**STAFF REPORT: 9-08-2021 MEETING**

**APPLICATION NUMBER: #21-7393**

**ADDRESS: 2071 LONGFELLOW**

**SCOPE: PAINTING OF PREVIOUSLY PAINTED MASONRY (WORK DONE WITHOUT PERMIT)**

Figure 1 Front and Right elevations by Applicant

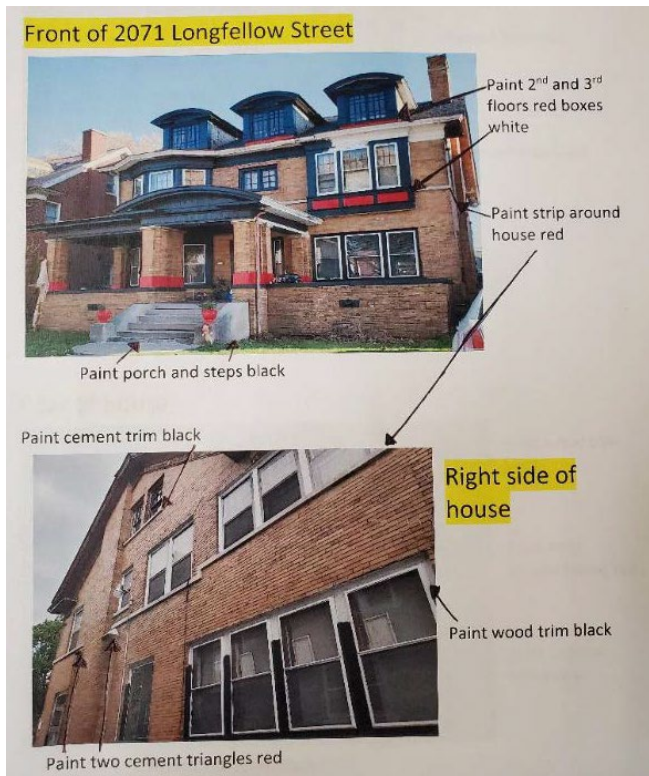
**B. Front Elevation – Paint**

- Elements that are already painted red (*Red Gumball*) include the following:
  - Porch brick pillar cast stone bases and capstones
  - Cast planters
  - Brick relief corners surrounding central windows on second floor
- Elements that are already painted black (*Black Onyx*) include the following:
  - Window sills and window brick inside edge
  - Porch wall cast-stone capstone

**C. Side Elevations - Paint**

- The cast planters in the front and rear of the house were not captured in the designation photo, and do not appear to character defining features of the house.

HDC staff recommends the Commission issue an approval for the below work items because they meet the Secretary of the Interior’s Standards for Rehabilitation and conform to the Elements of Design for the Boston Edison Historic District:

- For all **cast-stone, previously painted surfaces**, apply one color choice, confirmed by HDC Staff.
- For all **brick, previously painted surfaces**, apply one color choice, confirmed by HDC Staff.

- No additional paint be applied to unpainted masonry surfaces (ie., cast-stone, brick, etc.).
- Verify with HDC Staff final paint color choice and product prior to application.

Figure 2 Left and Rear Elevations by Applicant

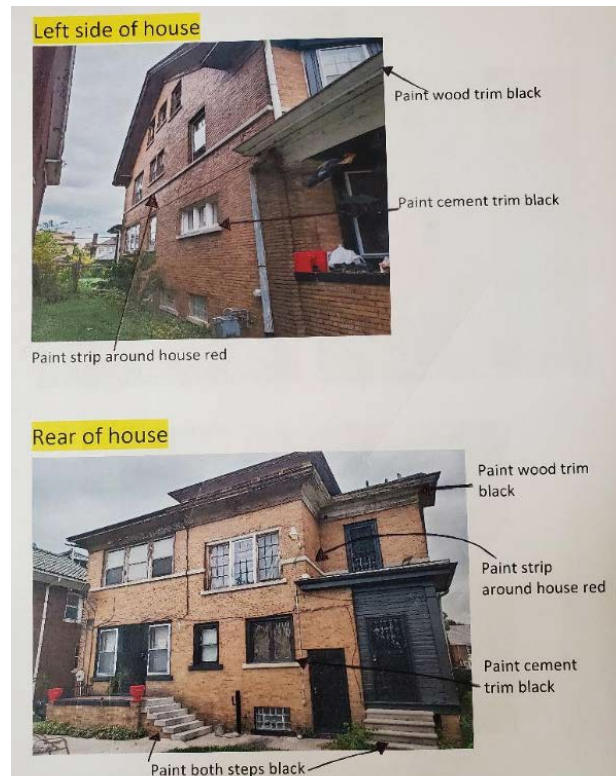
- Elements that are already painted black (*Black Onyx*) include the following:
  - Window cast-stone sills and window brick inside edge (West elevation only)

**D. Rear Elevation - Paint**

- Elements that are already painted red (*Red Gumball*) include the following:
  - Cast planters
- Elements that are already painted black (*Black Onyx*) include the following:
  - Window sills and window brick inside edge
  - Cast-stone rear porch capstone

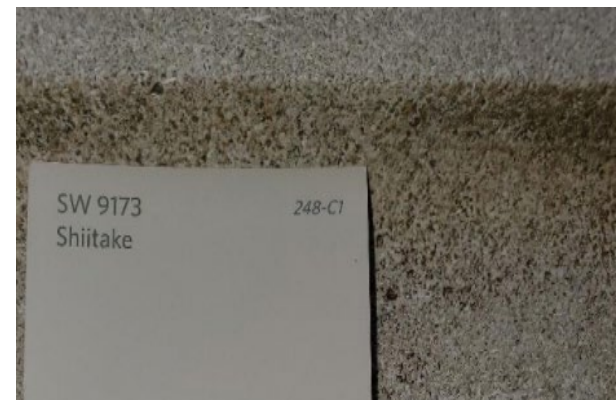
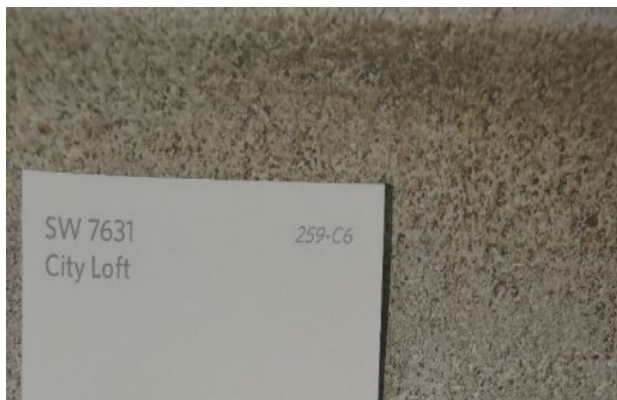
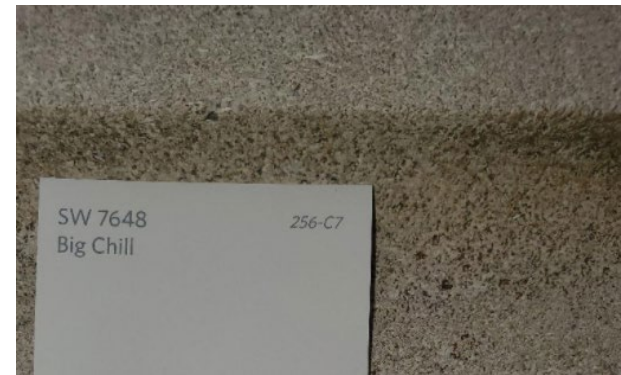
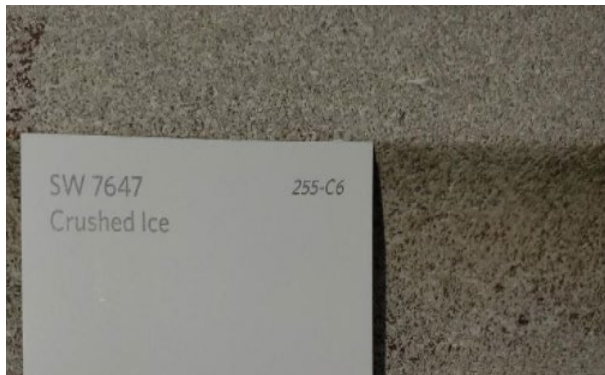
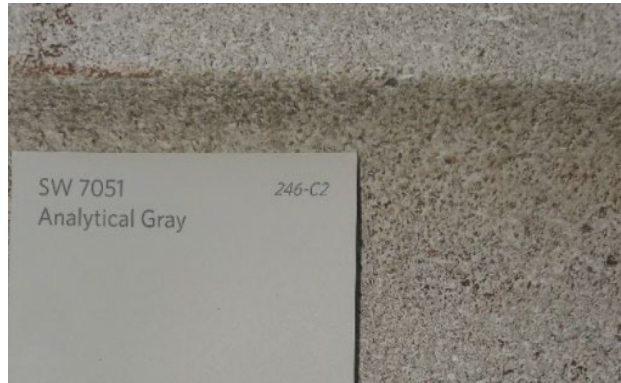
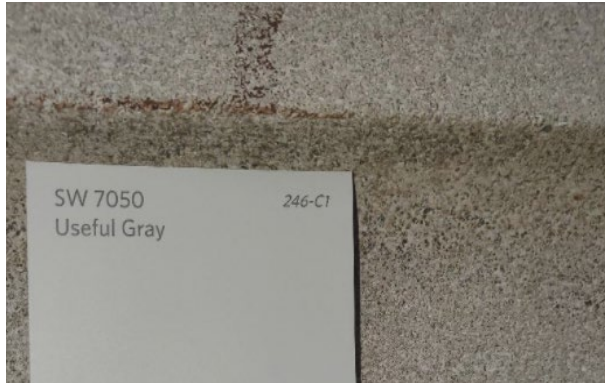
- i. SW 6380 “Humble Gold”
  - ii. SW 9012 “Polvo de Oro”
  - iii. SW 6361 “Autumnal”
  - iv. SW 9011 “Sun Bleached Ochre”
  - v. SW 6353 “Chivalry Copper”
  - vi. SW 9006 “Rojo Dust”
  - vii. SW 6375 “Honeycomb”
  - viii. SW 6339 “Persimmon”
- d. Except where noted above, no masonry or brick is proposed for additional painting.

I know that the brick that is painted black, a more uniform color matching the brick is required so I did the Sherwin Williams color match online to find colors that match the brick. I went to Sherwin Williams tonight and was able to obtain eight color samples that would be available in the Loxon breathable paint for masonry/concrete. Here are pictures of those samples which I place next to the brick.

- As the applicant has shown efforts to remove paint from both cast-stone and brick surfaces, Staff recommends that repainting already painted cast-stone and brick surfaces to one of the applicant’s proposed paint colors that attempts to match existing color of the masonry is an appropriate response. However, from the list of colors listed in the application, Staff recommends that applicant strike the following colors from the approvable list of colors as they do not appear to match the material as proposed:

- SW 6380 “Humble Gold”
  - SW 9012 “Polvo de Oro”
  - SW 9006 “Rojo Dust”
  - SW 6375 “Honeycomb”
  - SW 6339 “Persimmon”
- The applicant’s choice of the base paint, with a flat sheen, is appropriate.
